WESTERN VIRGINIA
WATER AUTHORITY
CONTRACT 3 - FY17
SANITARY SEWER
REPLACEMENT

Floraland Dr
EPPERLEY AVE
PLAN & PROFILE

Drawing No. **C-111**

SEWER PLAN

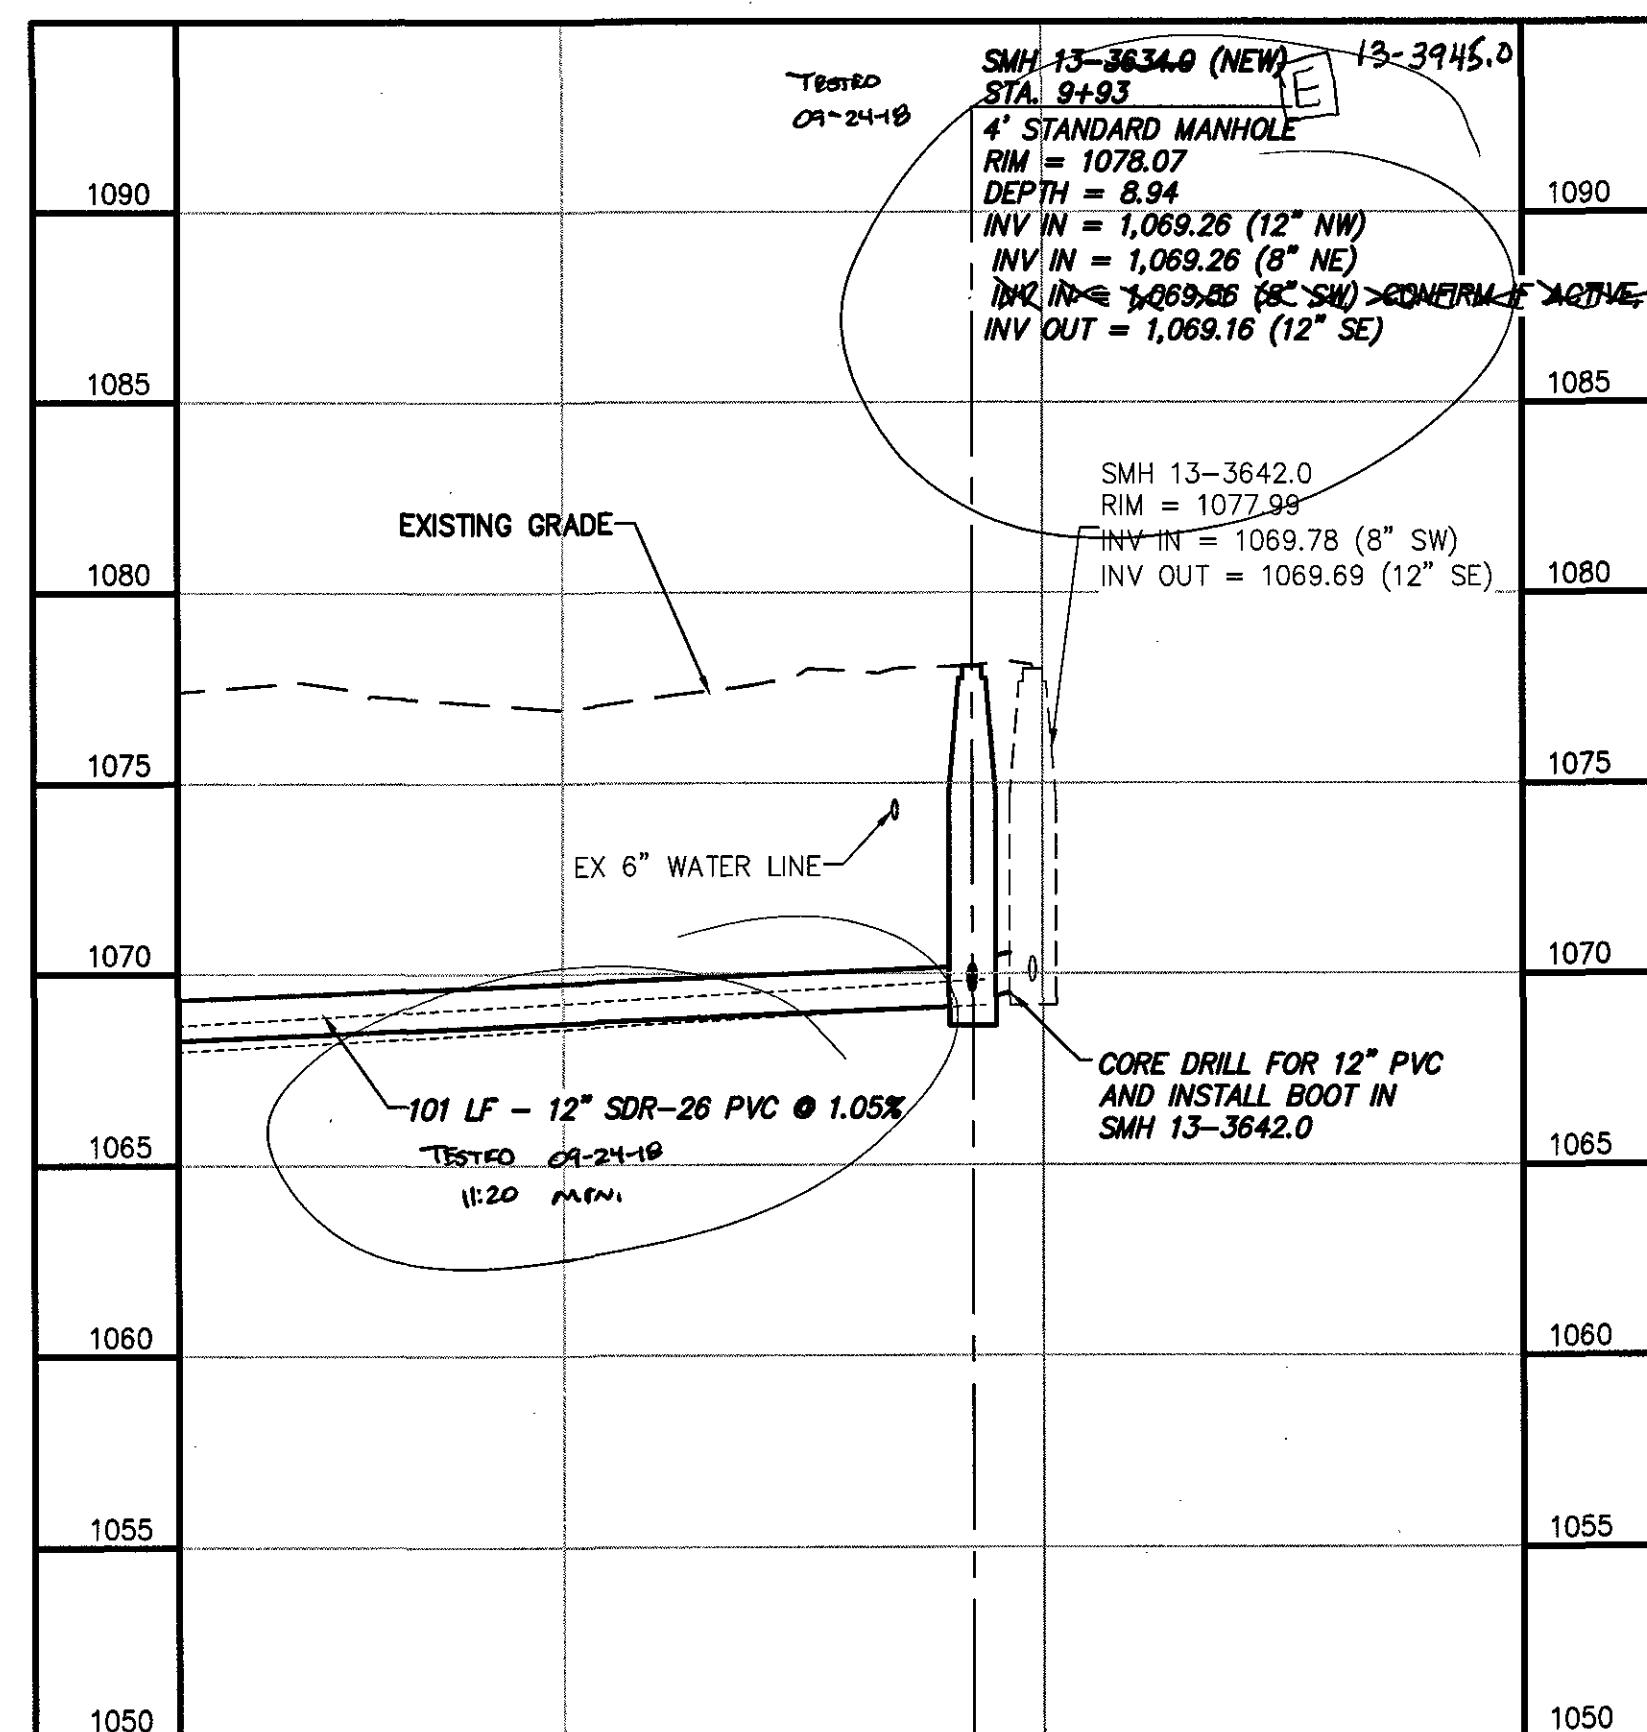
- CONFIRM IF 8" SEWER FROM SOUTH INTO SMH 13-3634.0 IS ACTIVE. DO NOT PROVIDE OPENING IN NEW MANHOLE IF ABANDONED. NOT ACTIVE. DID NOT RE-CONNECT.
